Title of Change:	AR0330CS Datasheet Update																																																													
Effective date:	4 January 2019																																																													
Contact information:	Contact your local ON Semiconductor Sales Office or <Sonya.Yip@onsemi.com>																																																													
Type of notification:	This Product Bulletin is for notification purposes only. ON Semiconductor will proceed with implementation of this change upon publication of this Product Bulletin.																																																													
Change Category:	<input type="checkbox"/> Wafer Fab <input type="checkbox"/> Assembly Change <input type="checkbox"/> Test Change <input checked="" type="checkbox"/> Other <u>Documentation</u>																																																													
Change Sub-Category(s):	<input type="checkbox"/> Manufacturing Site Addition <input type="checkbox"/> Material Change <input checked="" type="checkbox"/> Datasheet/Product Doc change <input type="checkbox"/> Manufacturing Site Transfer <input type="checkbox"/> Product specific change <input type="checkbox"/> Shipping/Packaging/Marking <input t

Figure 1. Block Diagram

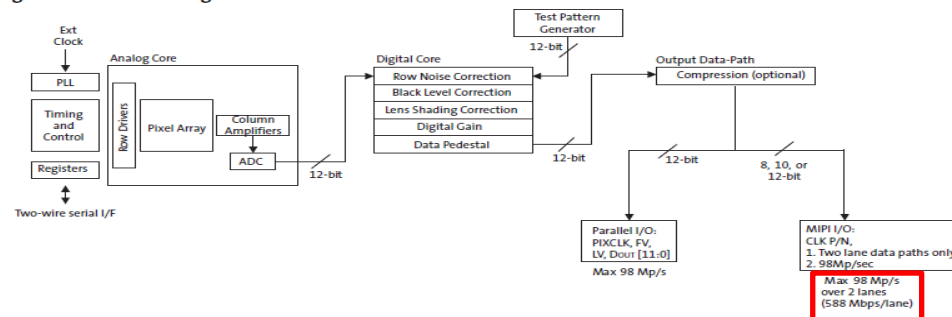
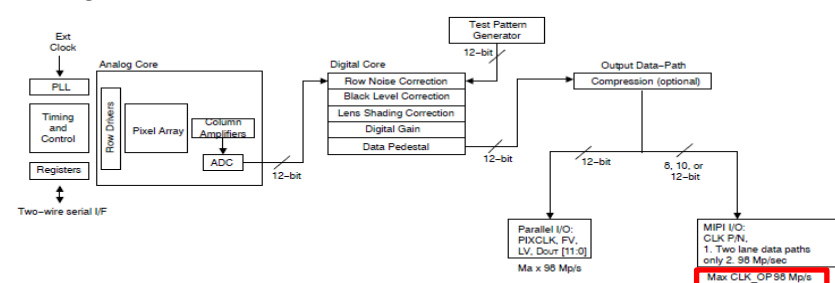
4. Updated Figure 1, "Block Diagram"

ODOSP64 6.278x6.648
CASE 570BH
ISSUE A

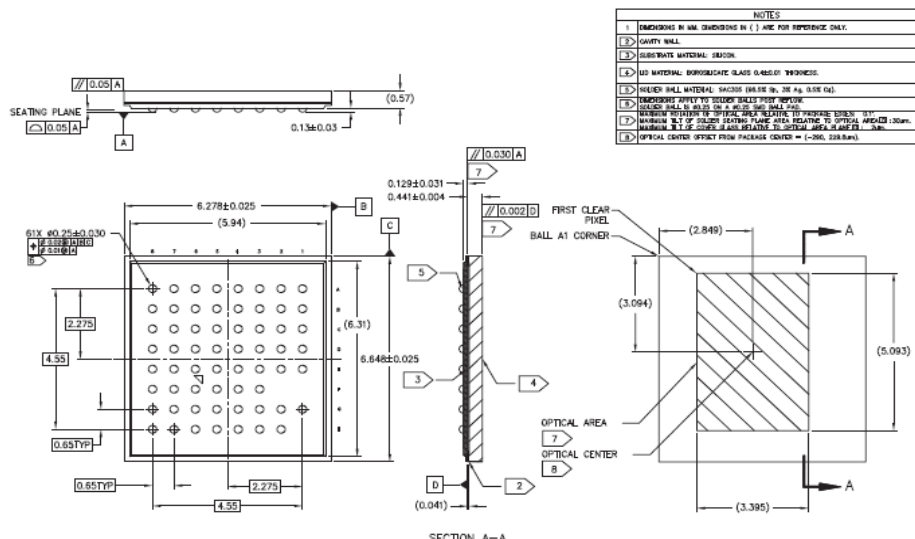
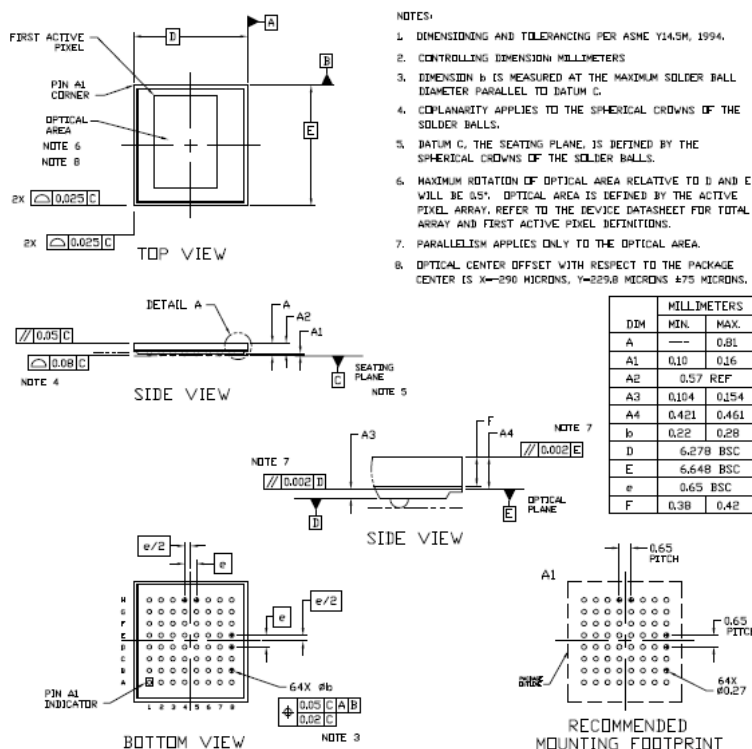
12. Updated "CSP Parallel/MIPI Package Drawing with official ON Semi case outline

PLCC48 11.43x11.43
CASE 776AM
ISSUE O

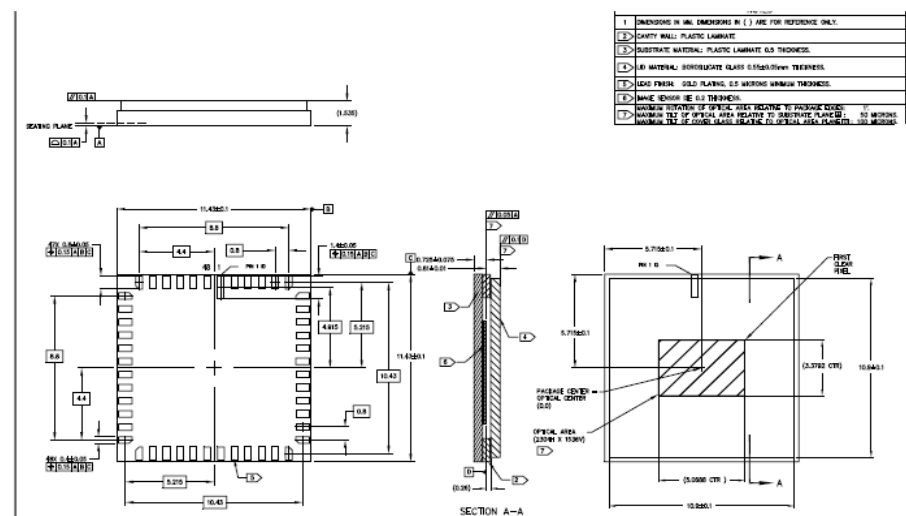
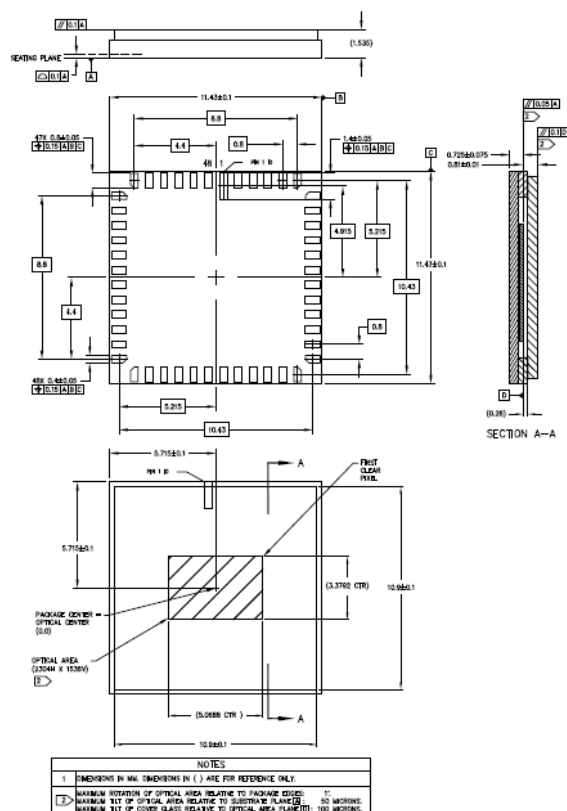
13. Updated PLCC Package Drawing with official ON Semi case outline
